Subject: Supporting Documents to Registration Certificate NR-655-D-101-S

This is in reference to your letter dated November 7, 1990, requesting additional information pertaining to your review of UTRC's August 16, 1990 application to amend registration certificate NR-655-D-101-S.

FIG. 2

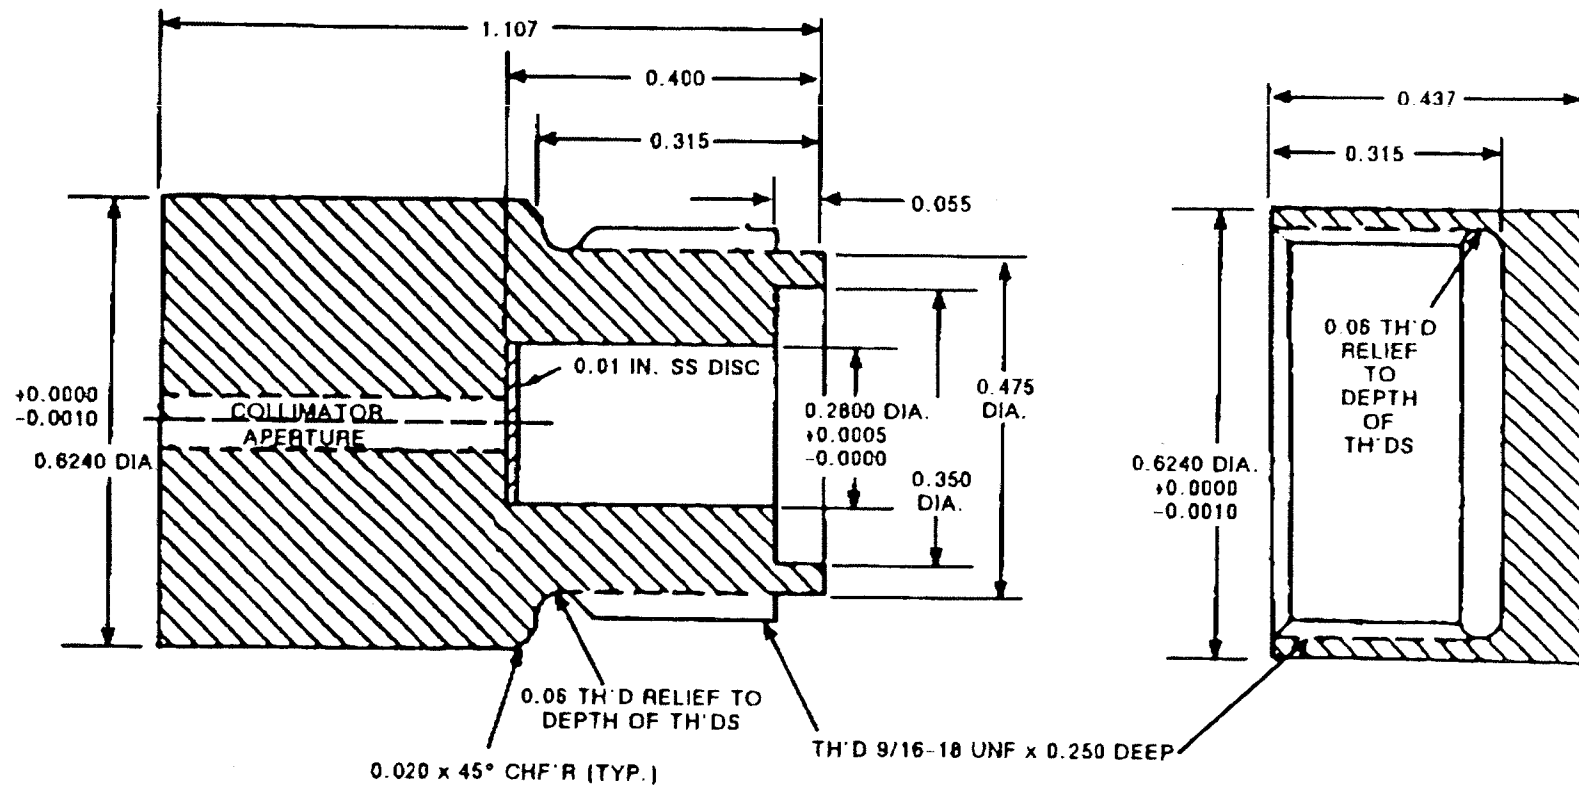
1. Figures 1-4 are original and revised drawings of the collimator and collimator holder. The revised collimator assembly has a larger cavity to accommodate the larger Amersham source, and a greater overall length to achieve the same degree of collimation (fig. 1 & 2). The outside diameter remains unchanged at 0.624 inches.

FIG. 3

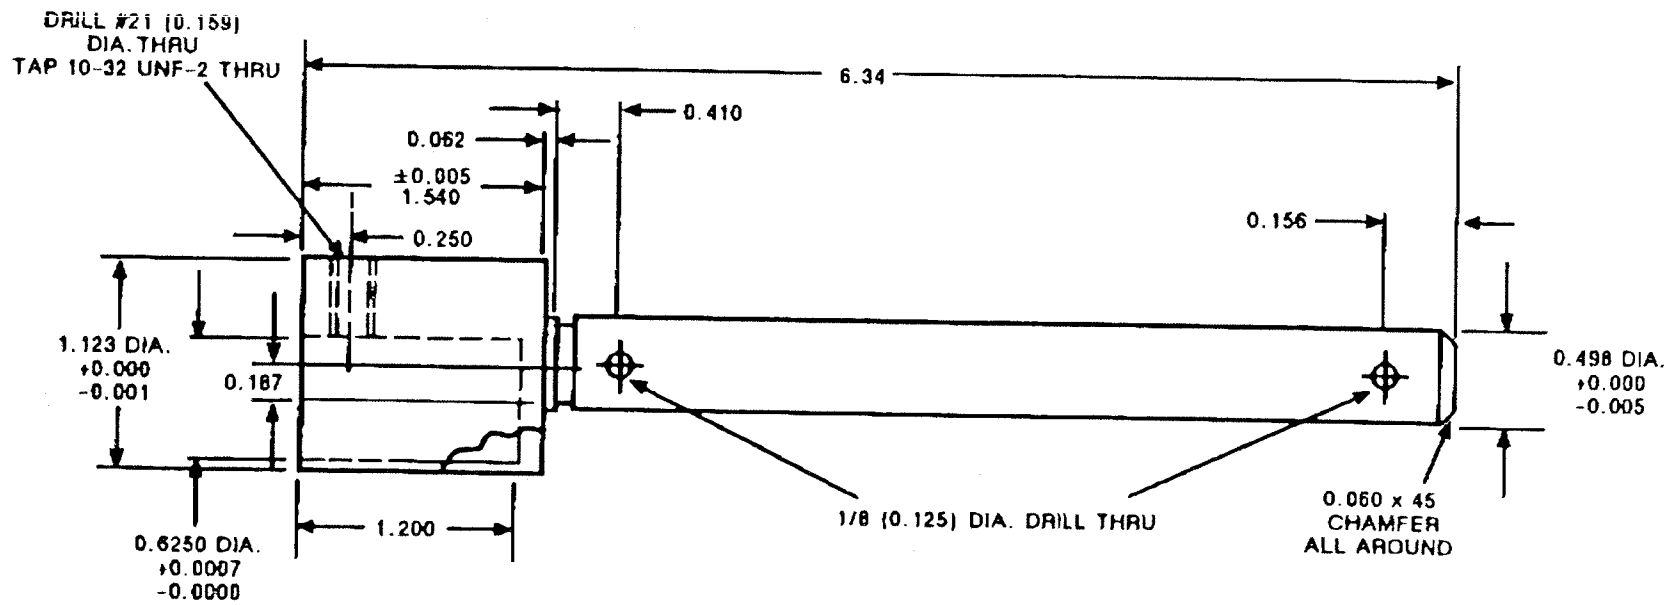
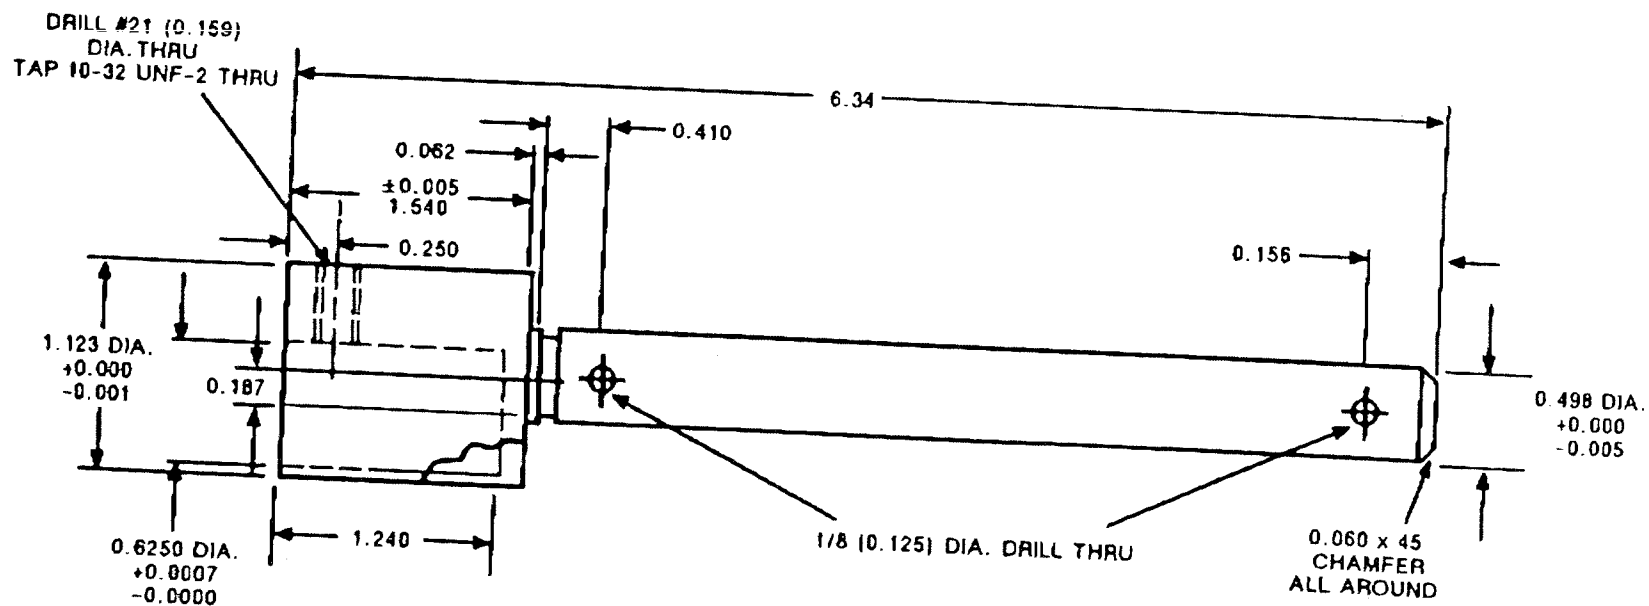
The depth of the collimator cavity in the collimator holder design had to be increased (fig. 3 & 4). This is the only collimator holder modification. The outer dimensions remain unchanged.
